COLLEX 472 BUYER MARKED PLAN

DOGWOOD **REVISION LIST - STRUCTURAL:**

DOGWOOD **REVISION LIST - ARCHITECTURAL:**

DREAM FINDERS HOMES

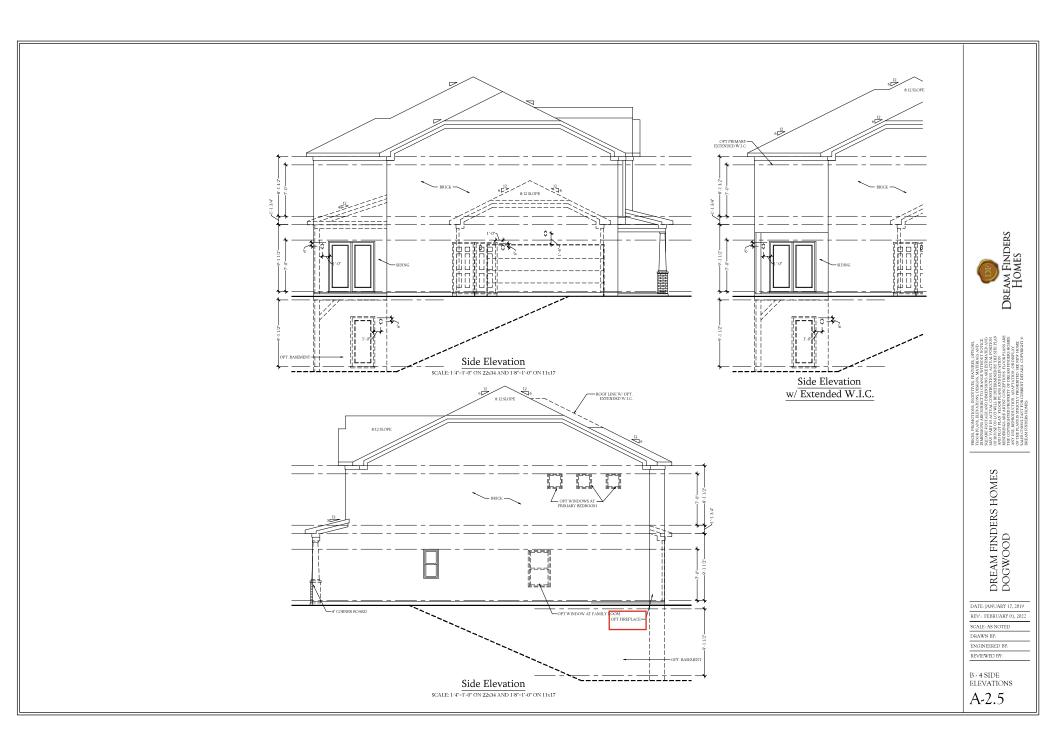
WINDOW AT OPTIONAL PRIMARY BATH 3 CHANGED FROM 2040 TO 4010 TRANSOM AND

MOVED TO CENTER LINE OF SHOWER
